Name of Project: Habitat Townhomes at CITISIDE
Address: 925, 929, 933, 937 Plaza Walk Drive - Charlotte, NC 28215
Proposed Use: Residential
Owner: Habitat for Humanity of Charlotte, Inc. Phone #: 704-376-2054
Contact Person: Carrie Masto Phone #: 980-253-1352
Owned By: ☐ City/County ☒ Private ☐ State
Code Enforcement Jurisdiction: ☒ Charlotte/ETJ ☐ Cornelius/ETJ ☐ Davidson/ETJ
☐ Huntersville/ETJ ☐ Matthews/ETJ ☐ Mecklenburg/ETJ
☐ Mint/ETJ ☐ Pineville/ETJ

Project #: 402787 Addr: 925 Plaza Walk Dr, Charlotte
Approved as Noted

APPROVED AS NOTED
20-Nov-2019

Sheet 1:

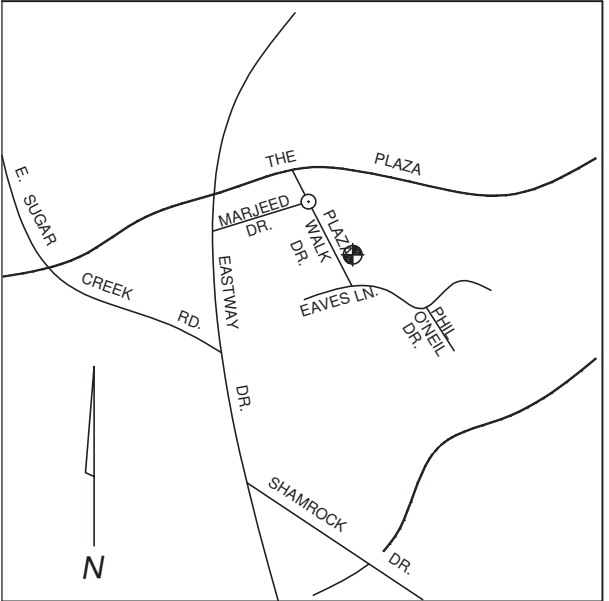
-U336 two-hour fire-rated area-separation wall utilized between units and at roof offsets with frame wall on each side of roof offsets. FRT roof sheathing used 4 ft. each way off demising wall in lieu of a parapet.
-Electrical, mechanical, fuel gas and plumbing are not part of review. -R310 Egress requirements met through recorded plat
-Field inspector verify #1 SP header lumber -Field inspector verify the opening of attic access 20" x 30" minimum net clear opening per R807.1 (TYP.) -Field inspector verify access hatches and door insulation per N1102.2.4 (TYP.) -Field inspector verify riser height, tread depth, nosing and headroom height details per R311 -Field inspector verify under-stair protection per R302.7
-Field inspector verify concrete and masonry foundation slab shall extend above the finished grade adjacent to the foundation at all points a minimum 6" per R404.1.6
-Field inspector verify Handrail Height shall be 34"-38" -Field inspector verify saw cut for roof sheathing on U336

① STAIR ELEVATION
SCALE: $\frac{3}{16}'' = 1'-0''$

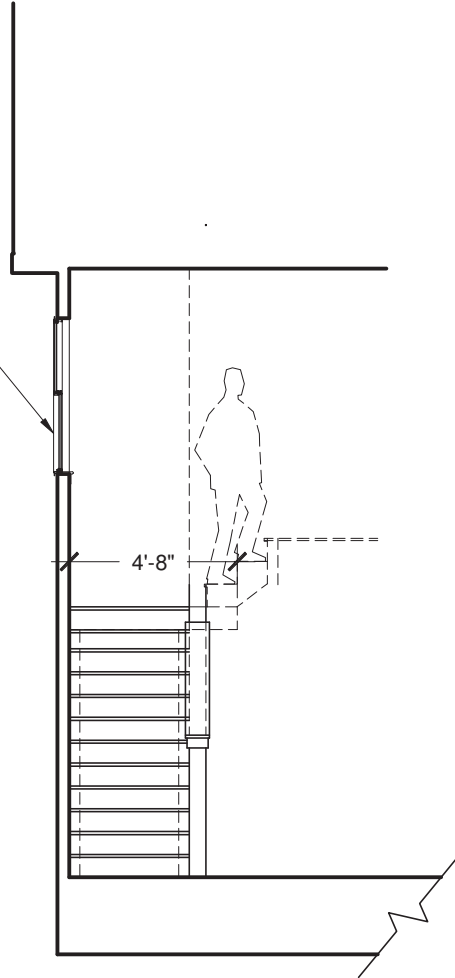
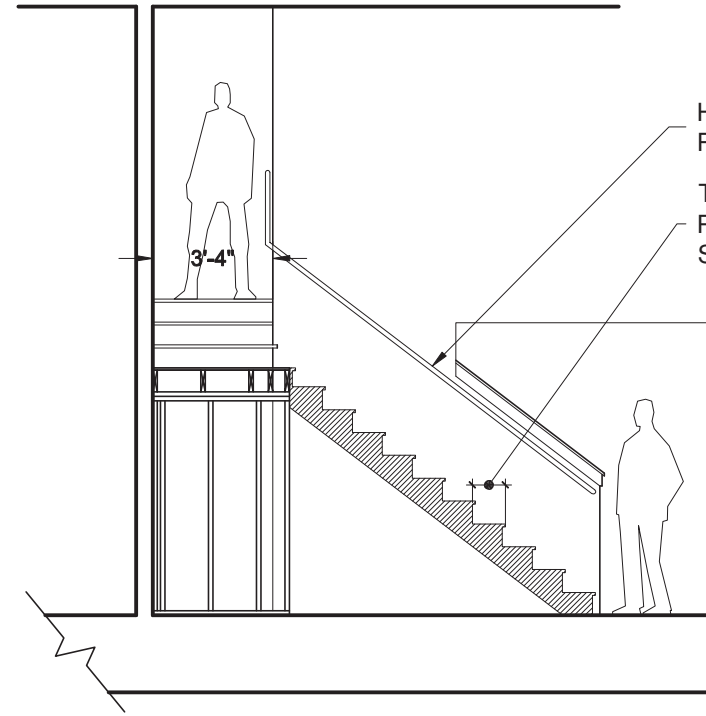
WINDOW HEIGHT
LOCATION IN
STAIRWELL, NOT AT
LANDING HEIGHT
